SERVICE BULLETIN

M-898

1984 TO 1985 FLT/FXR MODELS SERVICE MANUAL CORRECTIONS

The following corrections should be inserted in the FLT/FXR Service Manual, Part No. 99483-85. Cut along the dotted lines, peel off the backing and lay the corrected copy over the existing copy on the page and in the place indicated next to each correction.

Figure 7-10. Sprocket Nut Secured

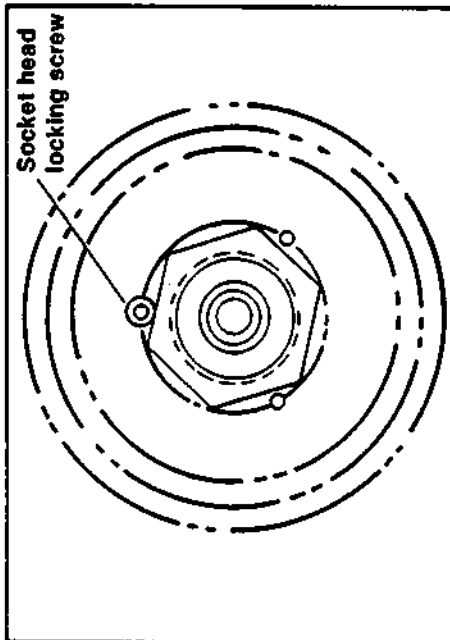
Page 7-9. Under "MAINSHAFT AND COUNTERSHAFT" and above Figure 7-11.

1. Remove the clutch as described in Section 6. Remove transmission top cover, shifter cam assembly and shifter forks as described earlier in this section. On 1985 models, remove the primary case and mainshaft support bearing race.
2. Remove the drain plug from the bottom of the transmission and drain the oil. Remove the side cover from the transmission side door. Lock the transmission by meshing the gears into two speeds at the same time and remove the locknuts and spacers from the shafts.
3. See Figure 7-10. If main drive gear (9, Figure 7-22) is to be removed, remove locking screw from sprocket and loosen sprocket nut using special WRENCH, Part No. HD-94660-37. Nut has left hand thread.

4. On 1985 belt drive models, it is necessary to remove the primary chaincase and bearing inner race from the transmission mainshaft prior to disassembly. The bearing inner race is removed by using BEARING RACE PULLER & INSTALLATION TOOL, Part No. HD-34902. See Figure 7-11.
5. See Figure 7-12. Remove the transmission side door mounting hardware. Pull the side door, mainshaft and countershaft from transmission case as an assembly.
